REGULATORY INFORMATION DISTRIBUTION SYSTEM (RIDS)

SUBJECT: Submits addl info re proposed license amend revised Tech Specs.

Re: Turkey Point Units 3 and 4
Docket Nos. 50-250 and 50-251
Proposed License Amendment
Revised Technical Specifications
Additional Information

**REACTOR PROTECTION SYSTEM AND ENGINEERED
SAFETY FEATURES SETPOINTS FSAR CHANGES**

FIGURE 7.2-11a

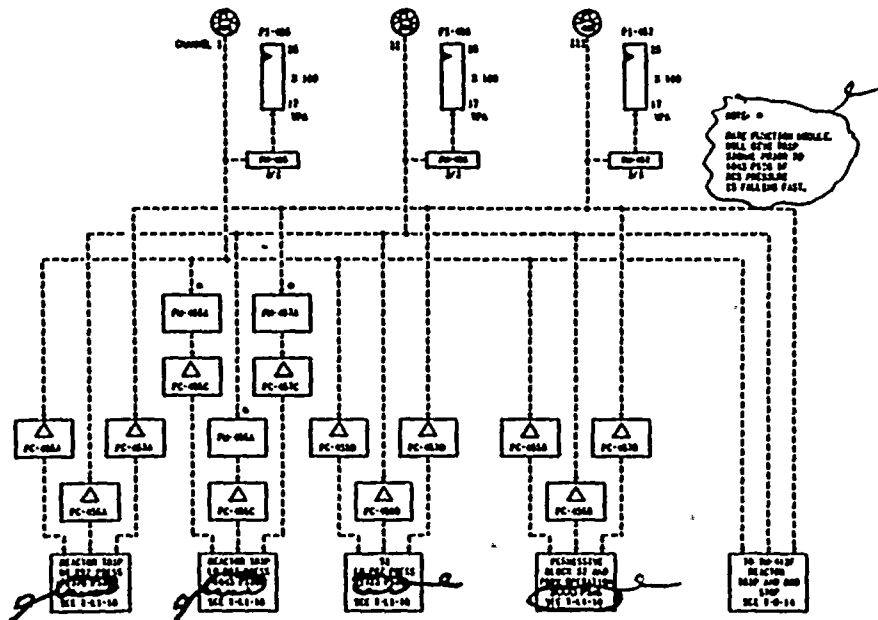
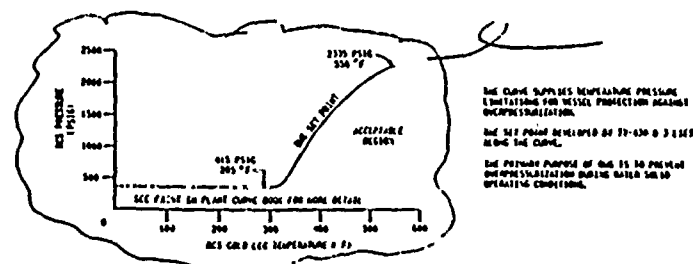
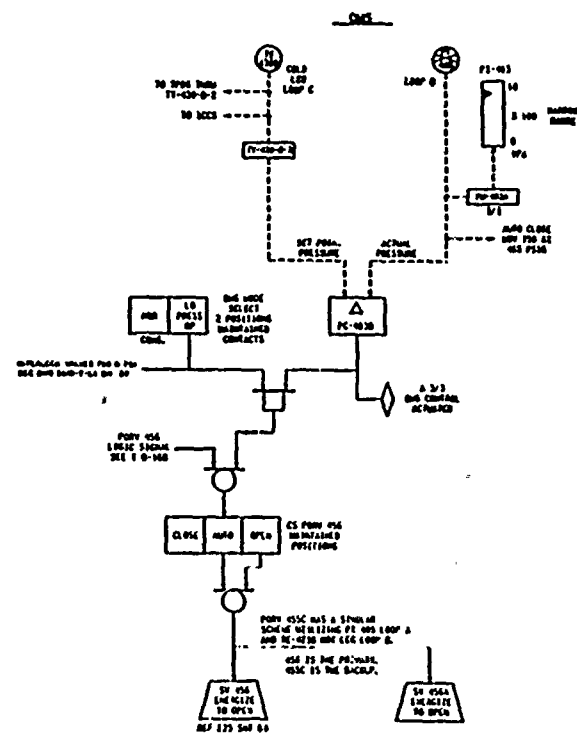
NOTE 5: See Technical
Specifications for
value.

FIGURE 7.2-11b

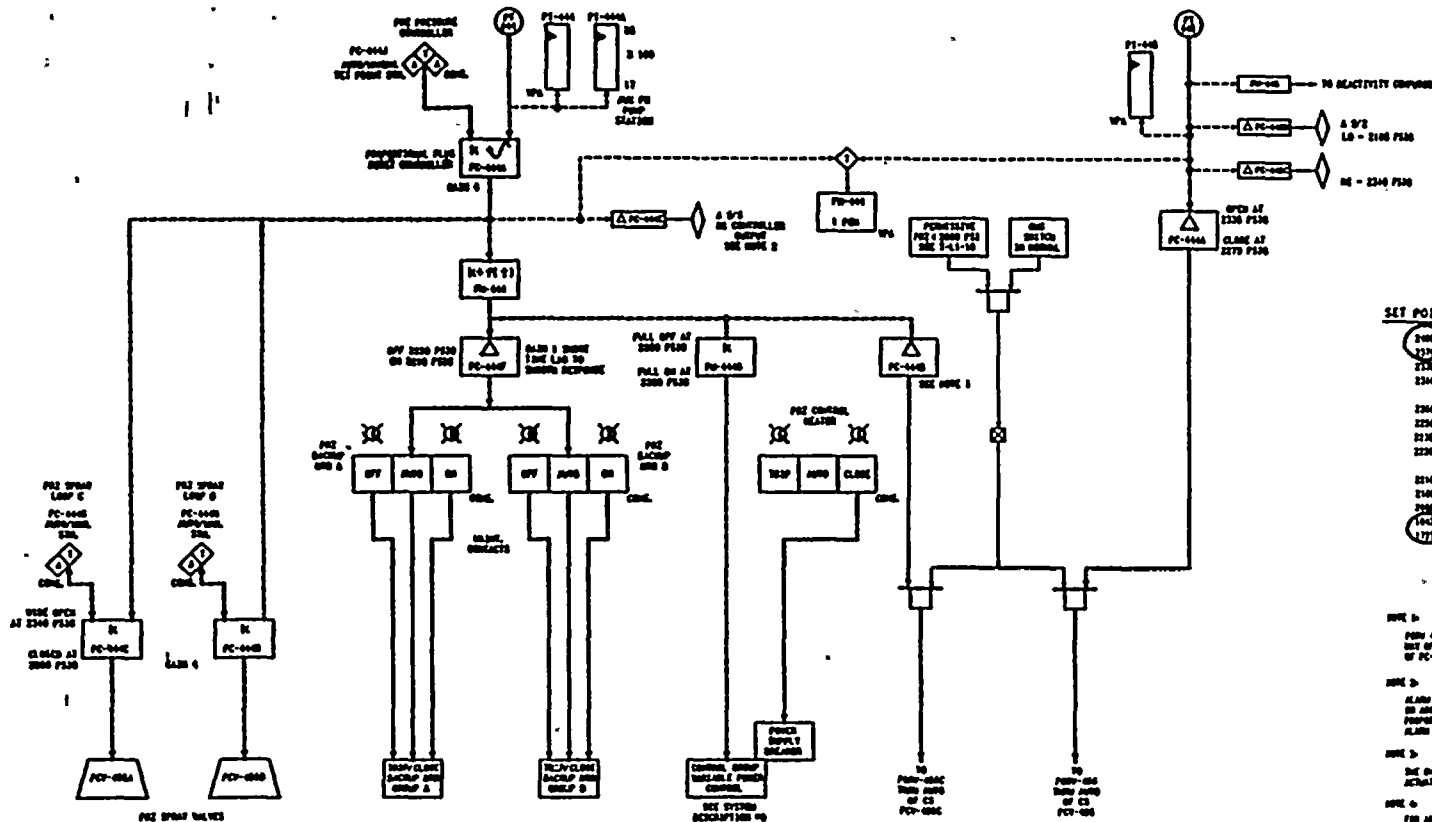
2000	SAFETY VALVES OPEN - See Note 5
2125	REACTION TRIP - See Note 5
2130	PRZ'S OPEN
2134	SPRAYS MODE OPEN
2136	BACKUP PRESSURE ALARM
2140	SPRAYS START TO OPEN
2150	CONTROL HEATERS FULL OFF
2156	NORMAL OPERATION
2160	BACKUP HEATERS OFF
2166	CONTROL, OP., FULL ON
2170	BACKUP HEATERS ON
2175	LO PRESSURE ALARM
2180	PERMISSIVE TO OPEN PRZ'S
2186	REACTION TRIP - See Note 5
2190	SAFETY INJECTION - See Note 5
